Project	IEEE 802.16 Broadband Wireless Access Working Group < http://ieee802.org/16 >	
Title	Ranging Channel Structure for Non-Synchronized MSs	
Date Submitted	2008-09-05	
Source(s)	HyunWoo Lee Young-Hyoun Kwon Jin Sam Kawk Sungho Moon LG Electronics LG R&D Complex, 533 Hogue-1dong, Dongan-gu, Anyang, 431-749, Korea	Voice: +82-31-450-1935 E-mail: camille@lge.com WishWill@lge.com samji@lge.com msungho@lge.com
Re:	PHY: Text; in response to the TGm Call for Contributions and Comments 802.16m-08/033 for Session 57	
Abstract	This contribution proposes the new ranging structure for non-synchronized MSs. A new ranging structure with the time-expanded concept in a localized band for IEEE 802.16m is proposed to enhance the ranging performance and coverage in accordance with the requirements in IEEE 802.16m SRD.	
Purpose	discussion and adoption for Project 802.16m SDD	
Notice	<i>This document does not represent the agreed views of the IEEE 802.16 Working Group or any of its subgroups. It represents only the views of the participants listed in the "Source(s)" field above. It is offered as a basis for discussion. It is not binding on the contributor(s), who reserve(s) the right to add, amend o

Figure x. Examples of ranging channel structure for non-synchronized mobile stations

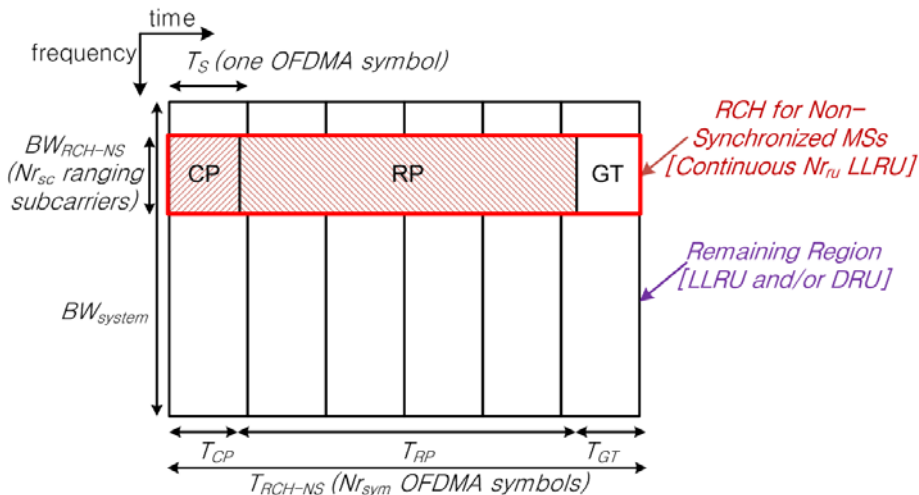
~~The ranging sequence design and mapping to subcarriers are TBD.~~

The physical ranging channel for non-synchronized mobile stations consists of three parts: 1) cyclic prefix (CP), 2) ranging preamble (RP) and 3) guard time (GT) as illustrated in Figure x. The length of CP shall not be shorter than the sum of the maximum channel delay spread and round trip delay (RTD) of supported cell size. The

length of GT shall not be also shorter than the RTD of supported cell size. The length of ranging preamble shall be equal to or longer than CP length of ranging channel. The details on the length of each part and its configurations are FFS.

The physical resource of ranging channel for non-synchronized mobile stations is consecutive Nr_{sc} ranging subcarriers (BW_{RCH-NS} Hz corresponding to continuous Nr_{ru} LLRUs) and Nr_{sym} OFDMA symbols (T_{RCH-NS} sec). As a default configuration, Nr_{sc} and Nr_{sym} are equal to [TBD] ranging subcarriers and 6 OFDMA symbols, respectively. The guard subcarriers shall be reserved at the edge of non-synchronized ranging channel(s) physical resource.
